New PET Membrane for Corning® FluoroBlok™ 3.0 μm and 8.0 μm Pore Size Cell Culture Inserts

Technical Bulletin 497

Figure 2. Total Transmission Spectra for 3.0 µm (top) and 8.0 µm (bottom) pore size Corning® FluoroBlok™ inserts as measured by transmission spectrophotometry using HunterLab UltraScan® PRO. Insets detail expanded y axis results.

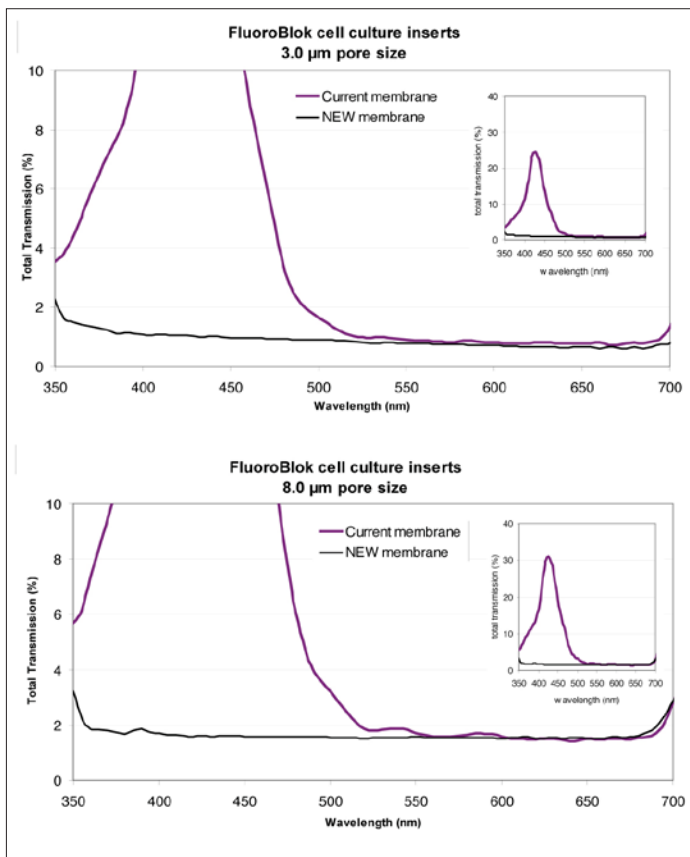
The new membranes allow less than 2% light transmission from 400 to 690 nm. This represents a two-fold reduction in light pass through (from 360 to 490 nm) when compared to the previous membrane. These enhancements permit the use of blue fluorescent dyes such as DAPI and the Hoechst stains for cell enumeration and multiplexing with increased confidence in results (see Figs. 2 and 5).

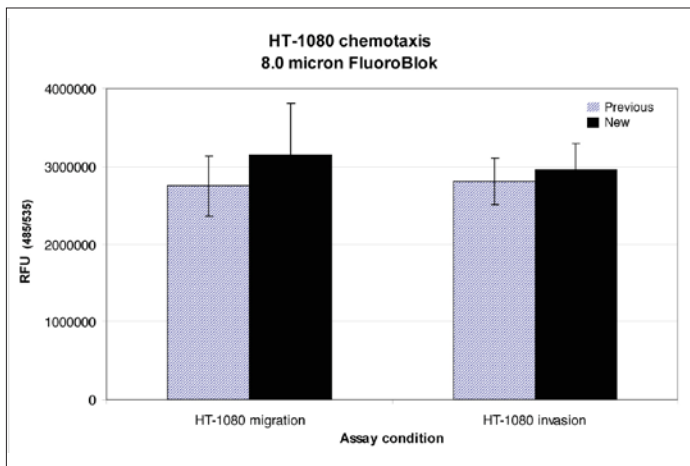
Results indicated no statistically significant differences in either cell migration or invasion between the previous and new membranes. Invasion indexes and Z' factors were comparable and consistent with previous results (ref. *Corning BioCoat™ Tumor Invasion System Guidelines for Use*, Corning Cat. No. 354165 and 354166).

Figure 4. HT-1080 stained with calcein AM. (A) previous membrane – migration, (B) previous membrane – invasion, (C) new membrane – migration, (D) new membrane – invasion.

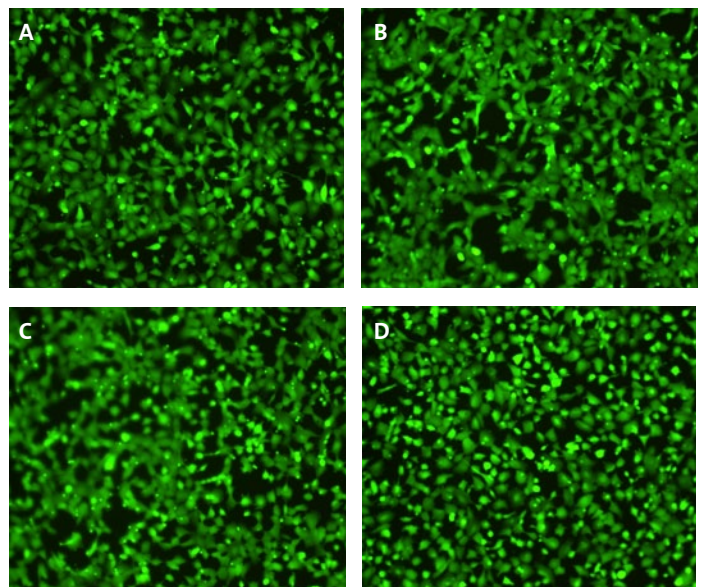
Corning FluoroBlok Inserts (8.0 μm pore size) were used in a model cell invasion assay. Invasive HT-1080 cells and non-invasive 3T3 cells (data not shown) were seeded in the apical chambers of both Corning Matrigel®-coated and uncoated inserts. Chemoattractant solution was added to the basal chambers of the system, and after overnight incubation, cells were stained with Corning Falcon® Calcein AM fluorescent dye, Corning Cat. No. 354216. Fluorescence was measured using a PerkinElmer EnVision® plate reader (see Figs. 3-5).
